190433(CSR) BJ/BM

23<sup>rd</sup> August 2023

**PROPOSED S4.55 (1A) MODIFICATION  
OF DA/2021/1662  
ONE (1) INTO ONE HUNDRED AND NINETY-THREE (190) LOTS TORRENS TITLE RESIDENTIAL  
SUBDIVISION IN TWO STAGES**

**Figure 1: Approved and Proposed Staging Plan**

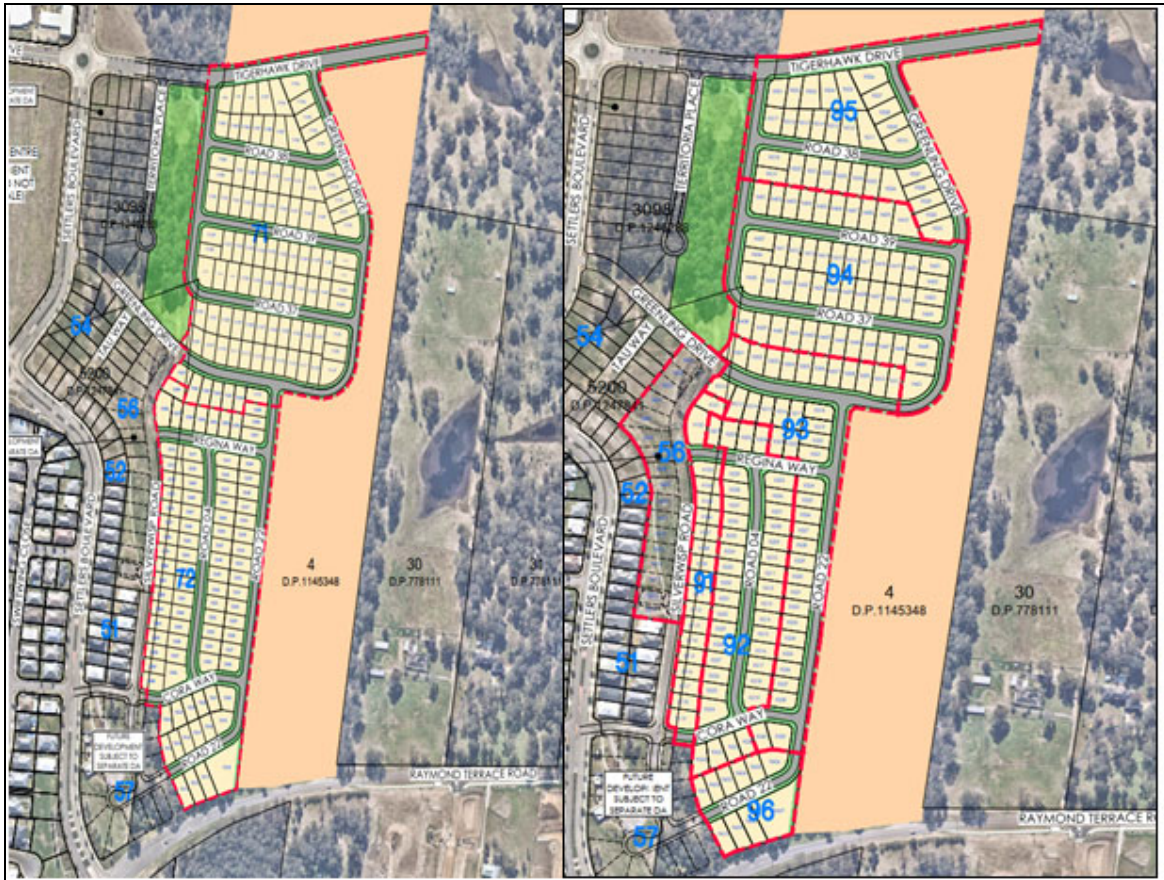
The proposed amendment for staging is to release smaller stages in response to the slowing market and rising costs. Recent increases in interest rates have resulted in higher holding costs along with experiencing increases to construction costs. By staging the development into smaller stages, it will allow for lower upfront development costs. A comparison of the approved and proposed staging is provided within Figure 1.

The construction of Tigerhawk Drive has been placed within proposed Stage 95. This is primarily to allow additional time to source and place fill at the former quarry located within proposed Stages 94 and 95. This sub-staging would provide the ability to release early stages while allowing the developer time to fill the abandoned quarry site. Deferring the quarry filling allows time to source nearby suitable fill, ensuring higher quality fill material and less disturbance on the Council Roads and to the residents within the locality.

Tigerhawk Drive acts as an east/west distributor road for the TNURA. The proposed staging includes Tigerhawk Drive in Stage 95, and is anticipated to be completed in 3-4 years which is well before they development to the east requires the transport link. Further, Tigerhawk Drive is also attached to a stage with 31 lots, which ensures there is commercial incentive to complete that stage, giving Council security in this regard.
